Certificate of Appropriateness

941 N. 29TH ST. Concordia Historic District

PTS ID 114055 COA Porch rebuild/repair

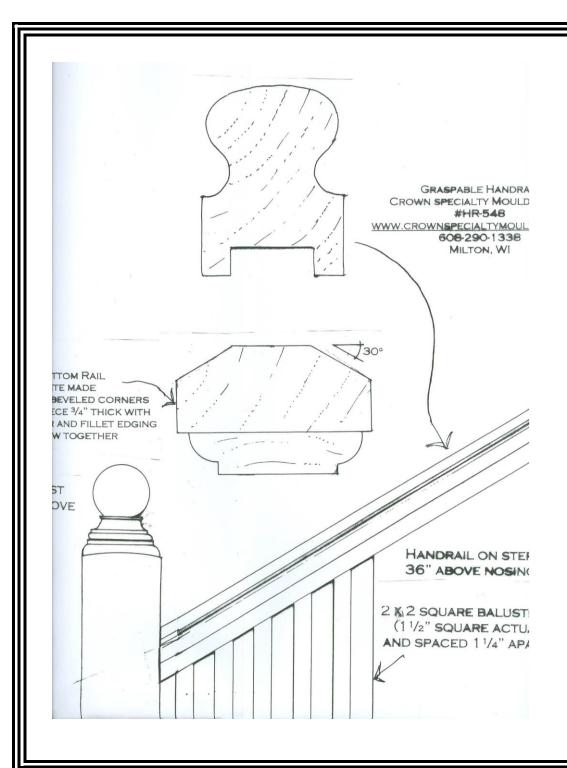
"Breadloaf" style handrails are meant to be easily graspable. Bottom rails need to shed water to prevent premature rot of the railing.

Balusters can be either 2-inch by 2-inch square pickets or turned as on the left. The turned baluster was salvaged from an earlier porch railing that is now gone.

The guard rails can be made of 2-inch by 2-inch pickets or turned balusters that match historic ones previously removed from the porch. It is recommended that the balusters be spaced 1 1/4 inches apart rather than 3 1/2 inches apart to look more authentic and provide a sturdier railing.
